16 July 2021

Request for information from Prime Property Group Limited in relation to Molesworth Street Office Development under COVID-19 Recovery (Fasttrack Consenting) Act 2020

Figure 1: The District Plan MaP

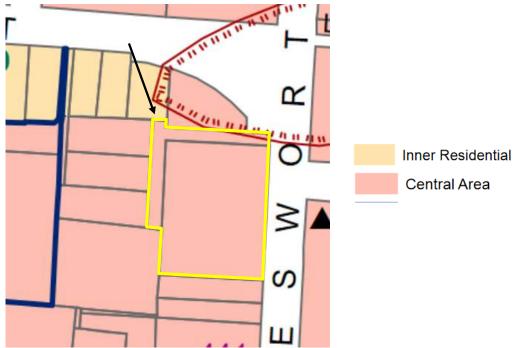
4. The Application at page 10 shows the Site as including Collina Terrace and refers to the definition of Site in Chapter 3.10 of the District Plan. Collina Terrace adjoins the carpark next door to the Red Cross building. This carpark is zoned Inner Residential. The Panel is yet to consider the interpretation of Site (and Site area) but it would assist the Panel if the applicant could provide elevations in the vicinity of where Collina Terrace adjoins the land zoned Inner Residential to demonstrate whether the Application can comply with Rules 13.6.3.1.9 and 13.6.3.1.10 (if applicable)?

To assist in this response, I firstly provide Figure 1, which is an extract from the District Plan maps which annotates the site and the relevant boundary.

The main title for the site does not adjoin a residential area. Only Collina Terrace adjoins a residential zoned property. The residentially zoned land in questions, is held by the New Zealand Red Cross known as 69 Molesworth St and is currently used as a car park.

The recession plane and yard rule applies to only this one boundary which is indicated by the arrow in Figure 1.

From this we can determine that the building recession plane is applied to the boundary at 90 degrees to the relevant bearing of the boundary. In this case, the residential boundary adjoins only Collina Terrace and does not therefore come into effect for the main site i.e. the height recession plane does not cut into the building and therefore full compliance is achieved.
